SI B 11 05 03
Engine

Recall Campaign 03V - ■ 324: Retorque of Oil Drain Plug Located on Oil Filter Cover

745i, 745Li, and 760Li produced from 5/20/2003 through 7/18/2003

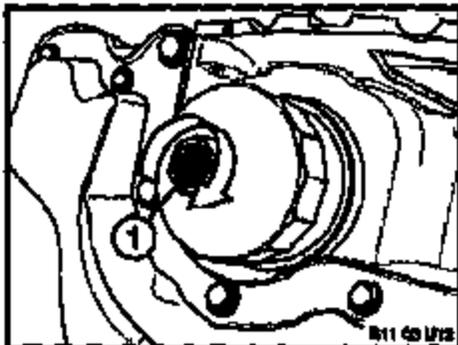
Tighten the Allen Head screw, located within the oil filter cover hex nut, to the correct torque.

Raise vehicle on hoist. Utilizing an appropriate torque wrench, retorque the 6 mm Allen Head screw (shown as "1" in illustration below) to 10 Nm. Clean any residual oil from the surface of the oil pan and ensure that there is no further leakage.

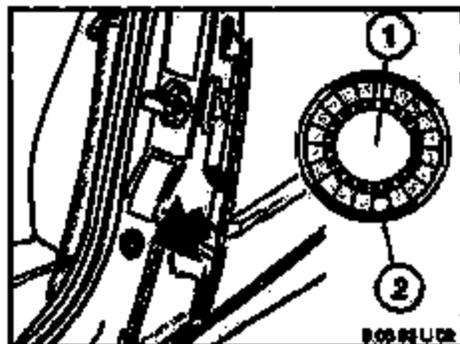
- emboss your BMW dealer warranty number in the middle of the label (1);
- punch out code number 368 printed on the label and,
- affix the label to the B pillar as shown.
